**SUBJECT: Transmittal of Responses to AP1000 DSER Open Items**

1. List of the AP1000 Design Certification Review, Draft Safety Evaluation Report Open Item Responses transmitted with letter DCP/NRC1628
2. Proprietary AP1000 Design Certification Review, Draft Safety Evaluation Report Open Item Responses dated September 23, 2003
3. Non-Proprietary AP1000 Design Certification Review, Draft Safety Evaluation Report Open Item Responses dated September 23, 2003

## Draft Safety Evaluation Report Open Item Response

Figure 9 – Isometric View: Comparison of AP600 and AP1000 DVI-A Piping System

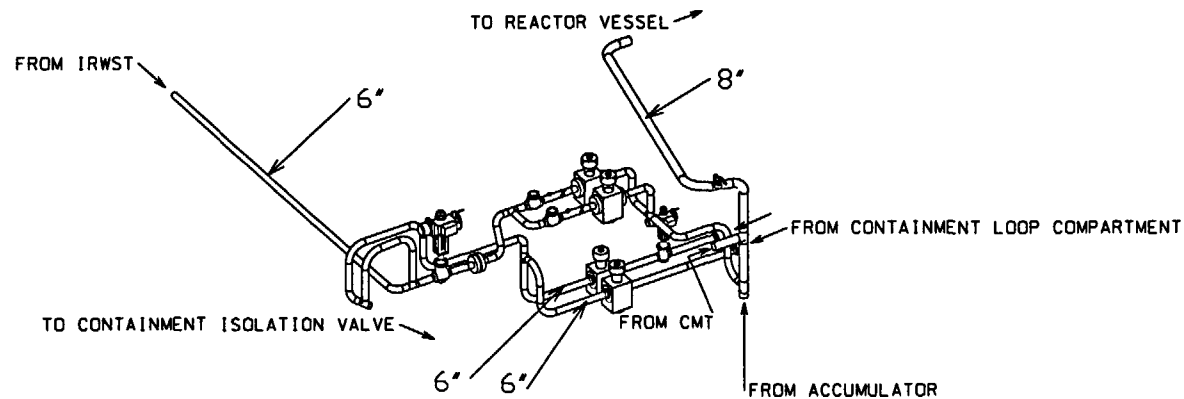
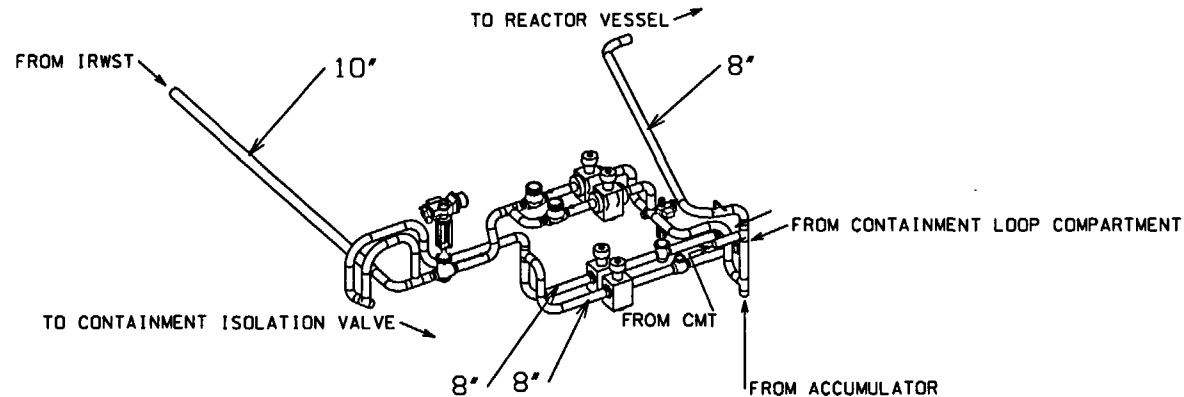
**Complexity of piping system** - The DVI-A piping system is complex, and was particularly challenging to qualify for the AP600. The AP600 design and analysis of the DVI-A subsystem was performed over several iterations that included perturbations in the piping layout, support configuration, and piping analysis. Figure 9 shows isometric views of both the AP600 and AP1000 DVI-A piping system.

Figure 16 - Bounding Analysis Curve – Primary Loop Hot Leg – 31”

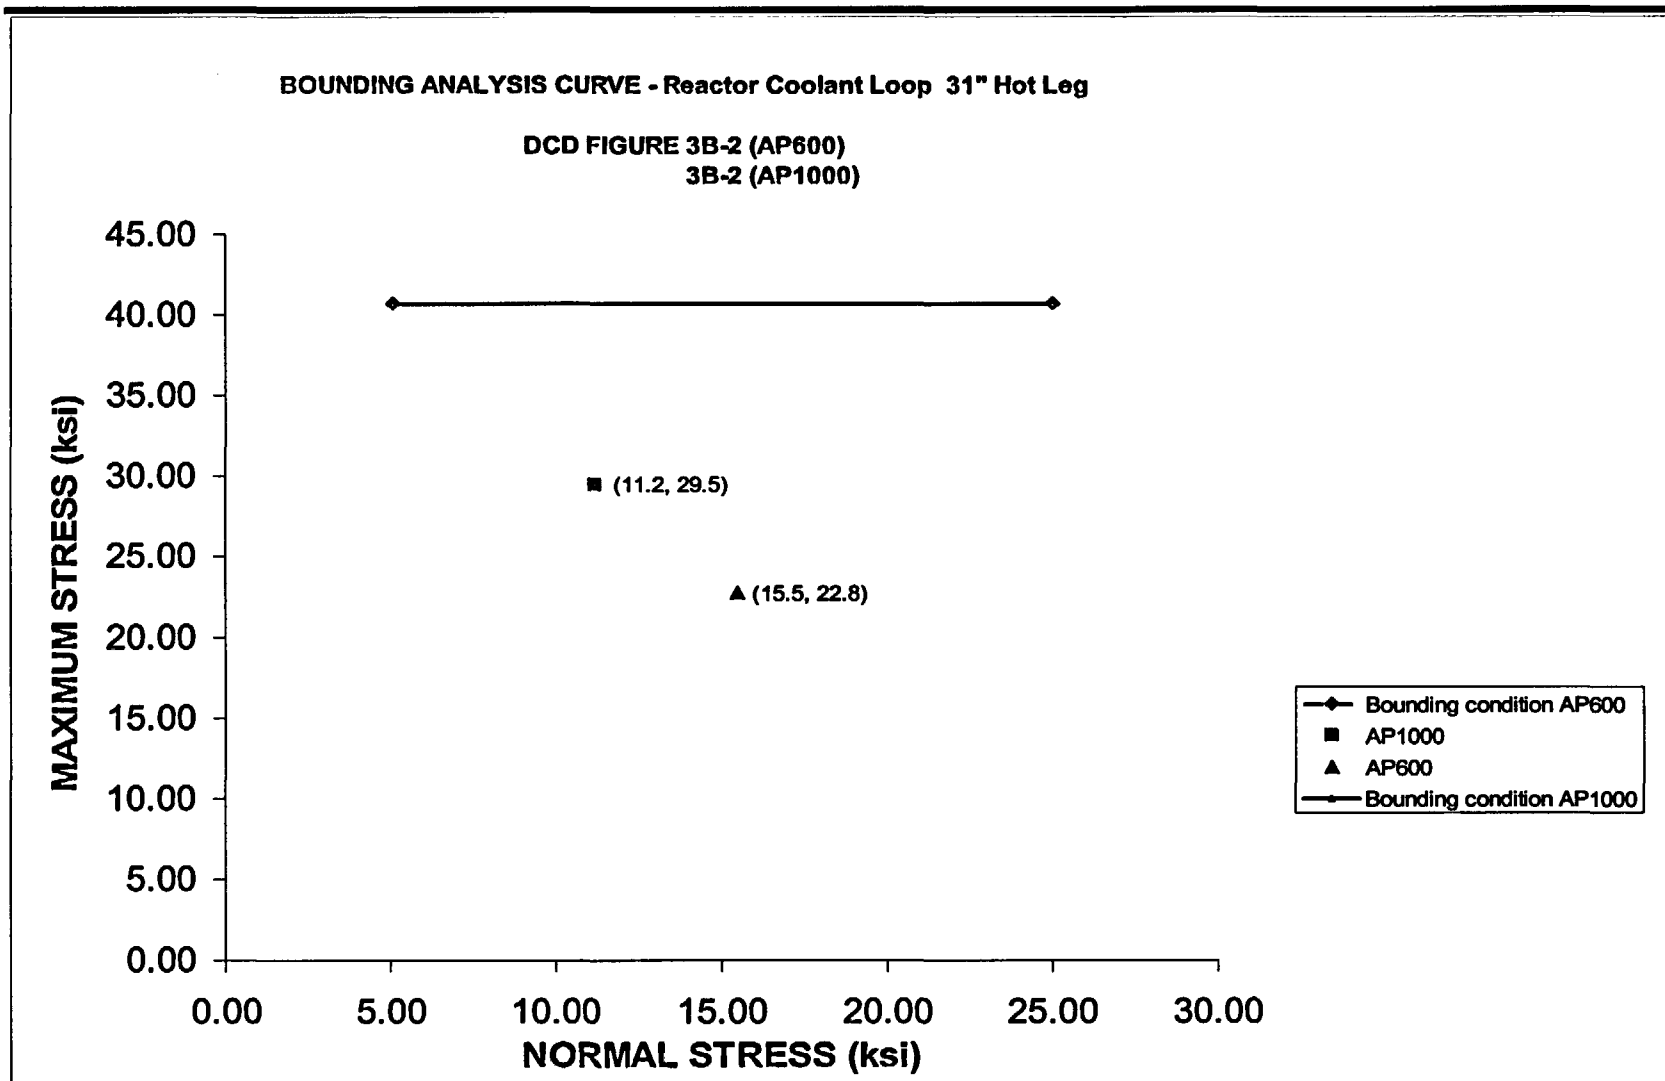
#### 3.1 Primary Loop Hot Leg (31") – (Reference AP1000 DCD Figure 3B-2)

The Hot Leg pipe diameter is the same as AP600. The seismic multiplication factor is 1.74. This includes the affect of the higher elevation of the steam generator upper lateral support. The maximum stress is 29.5 ksi which is less than the BAC stress of 40.7 ksi. Figure 16 shows the BAC and the estimated stresses for the AP1000 plant. Feasibility of LBB for AP1000 is confirmed.

Figure 17 - Bounding Analysis Curve – Primary Loop Cold Leg – 22"

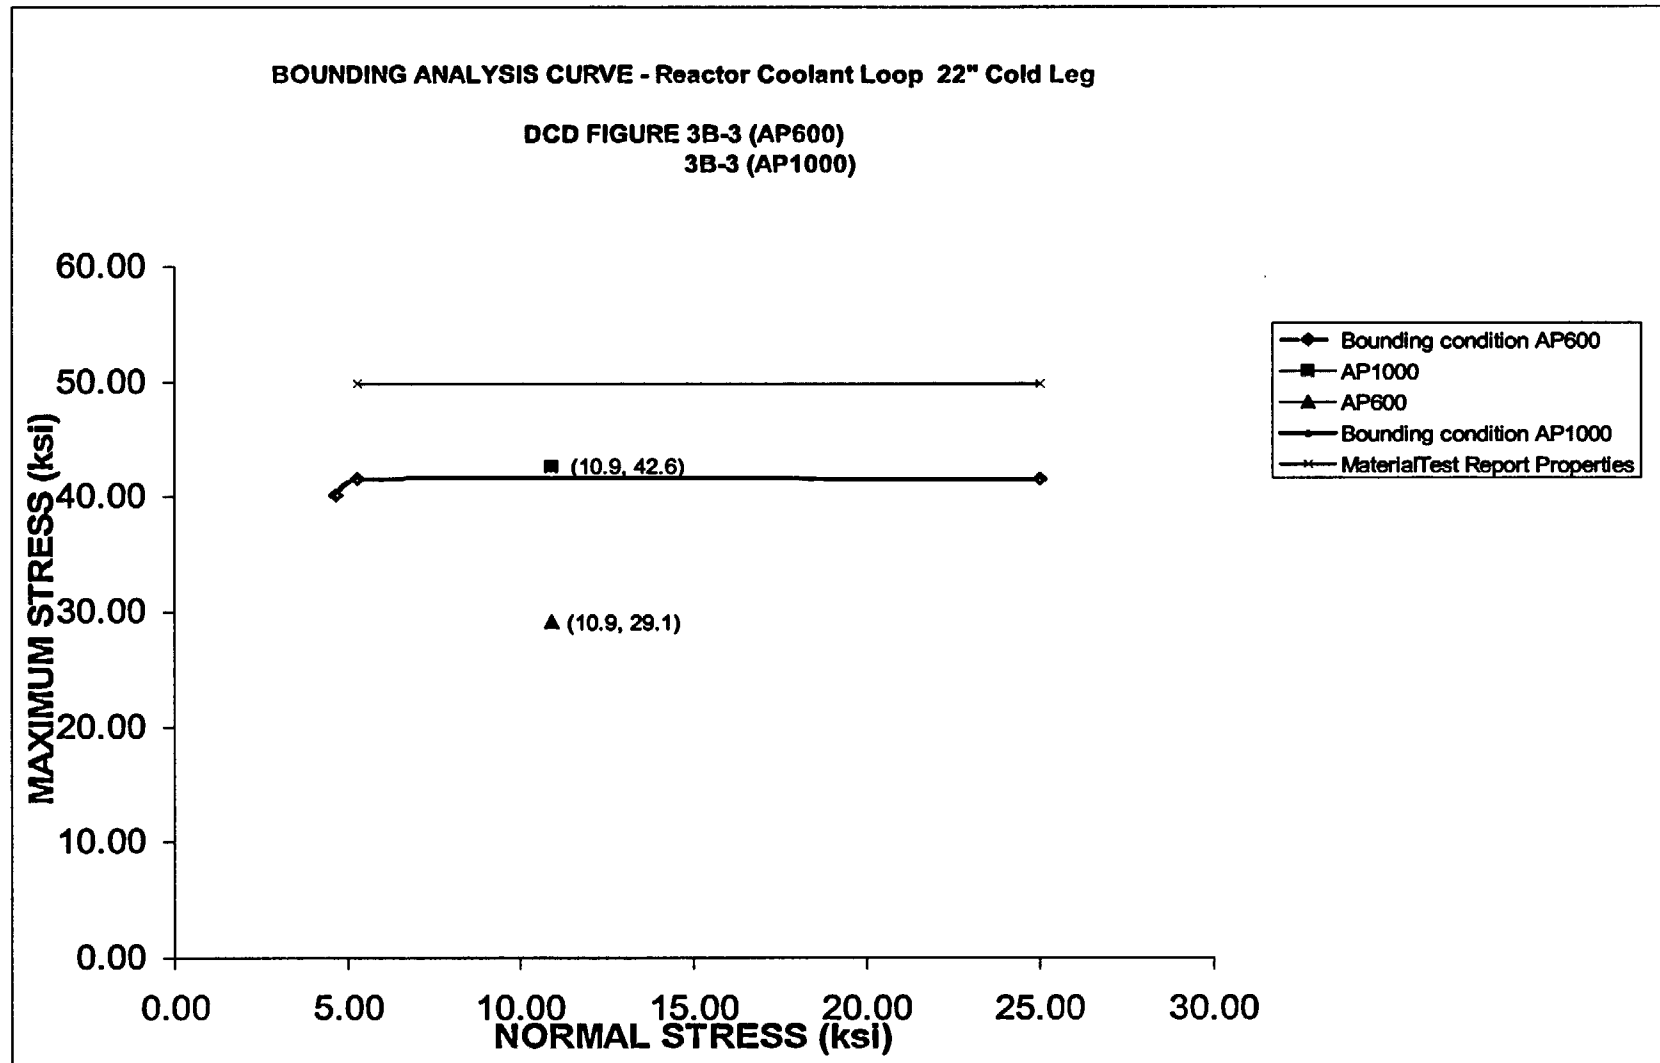
### **3.2 Primary Loop Cold Leg (22") – (Reference AP1000 DCD Figure 3B-3)**

The Cold Leg pipe diameter is the same as AP600. The seismic multiplication factor is 1.74. This includes the affect of the higher elevation of the steam generator upper lateral support. The maximum stress is 42.6 ksi which is lower than the modified BAC stress of 49.9 ksi. Figure 17 shows the BAC and the estimated stresses for the AP1000 plant. Therefore, the feasibility of LBB for AP1000 is confirmed.

Figure 22 - Pressurizer Safety Valve Inlet Pipe Break Protection (Sheet 1 of 2)

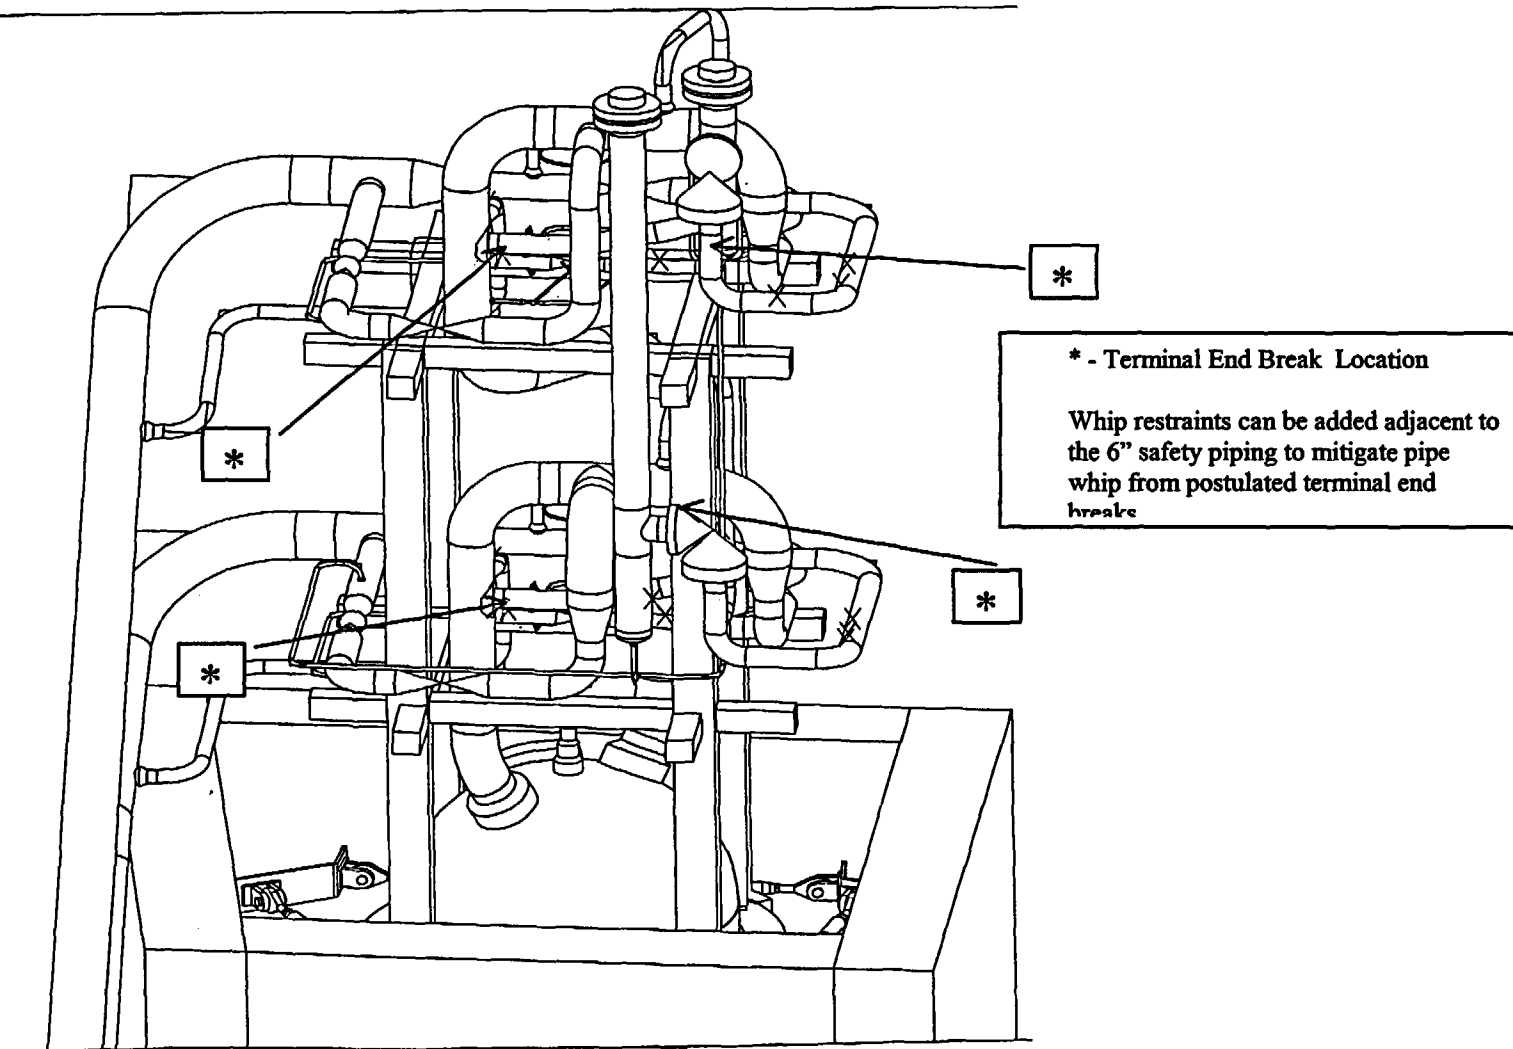
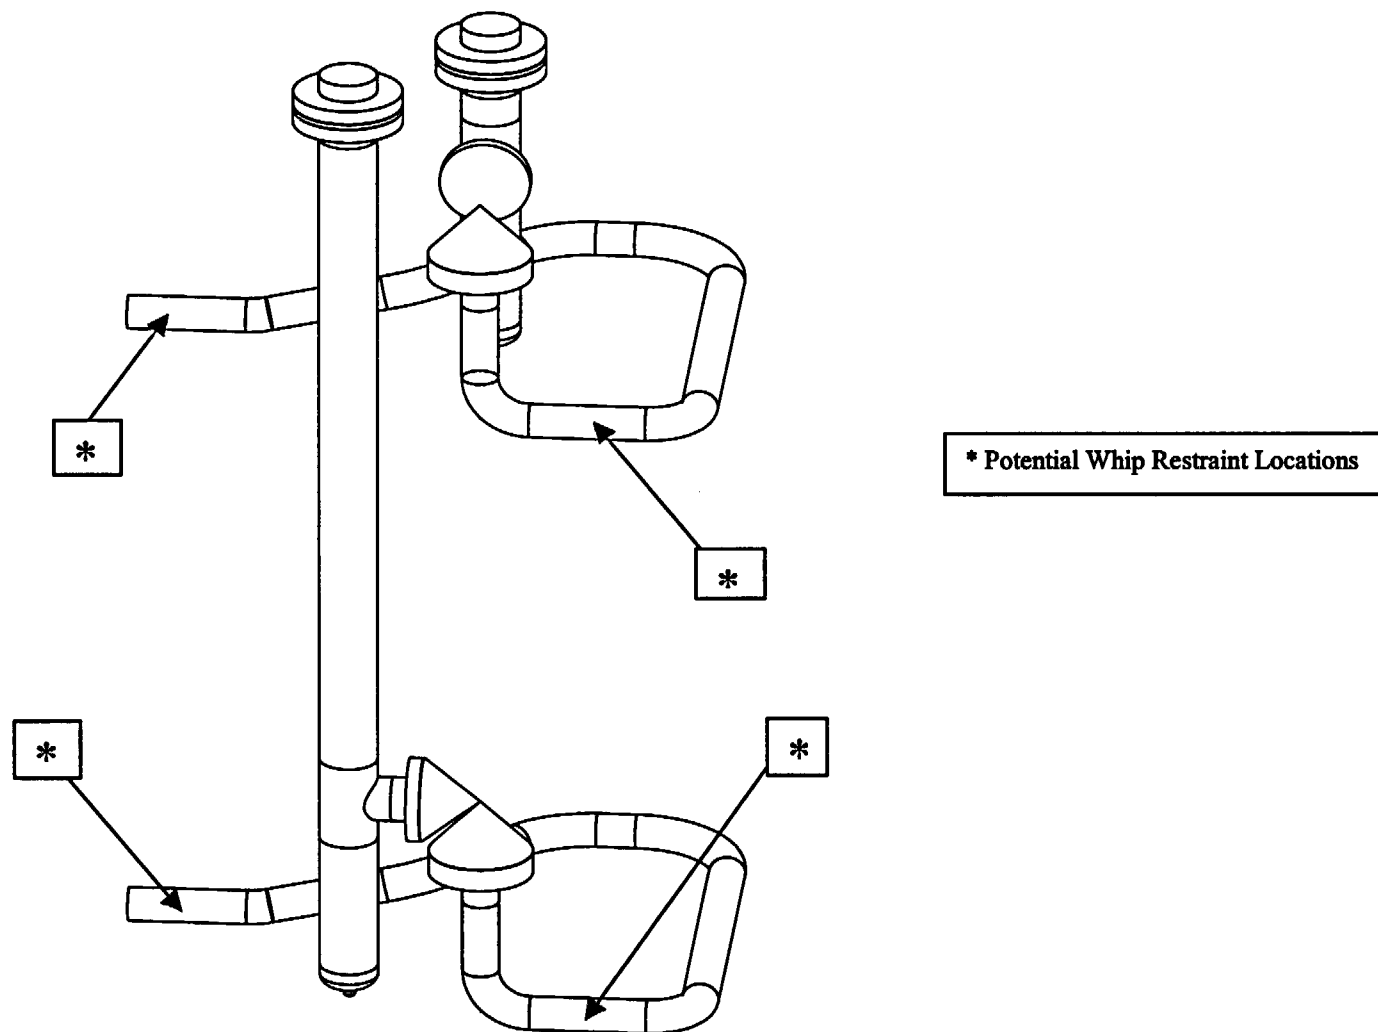
This report summarizes an assessment of applying Leak-Before-Break methodology to the candidate AP1000 plant pipe lines listed in Table 1. Feasibility is demonstrated for the LBB candidate piping systems with one possible exception of the Pressurizer Safety Valve inlet piping (6"). For these two lines, the high energy pipe breaks can be mitigated by the installation of protection devices (whip restraints) as shown at the locations in Figure 22 if required.

Figure 24 - Bounding Analysis Curve – ADS Stage 4 – 14" (610 °F)

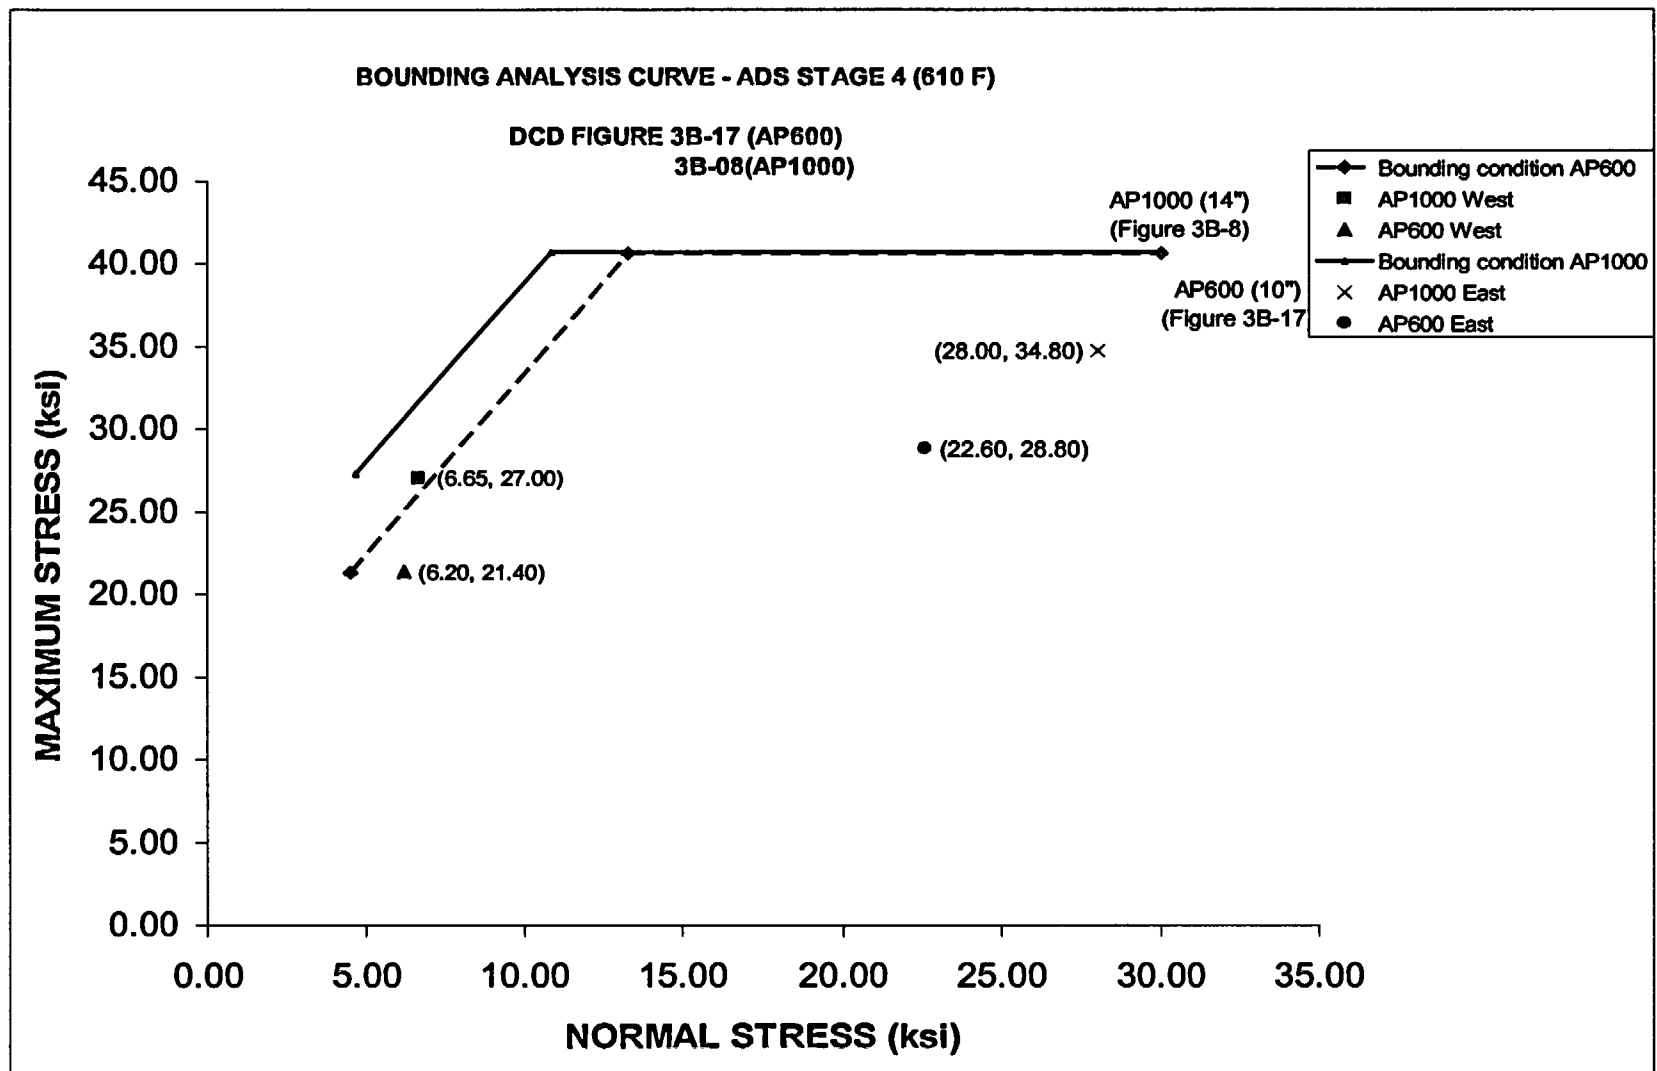
### 3.10 ADS Stage 4 West (14"- 610F) – (Reference AP1000 DCD Figure 3B-8)

The ADS Stage 4 pipe diameter is larger than the AP600 (10"). The seismic multiplication factor is 1.74. This includes the affect of the higher elevation of the steam generator upper lateral support. The maximum stress is 32.7 ksi before adjustment for pipe diameter and 27.0 ksi after adjustment. The adjusted stress is less than the corresponding BAC stress of 31.6 ksi. Figure 24
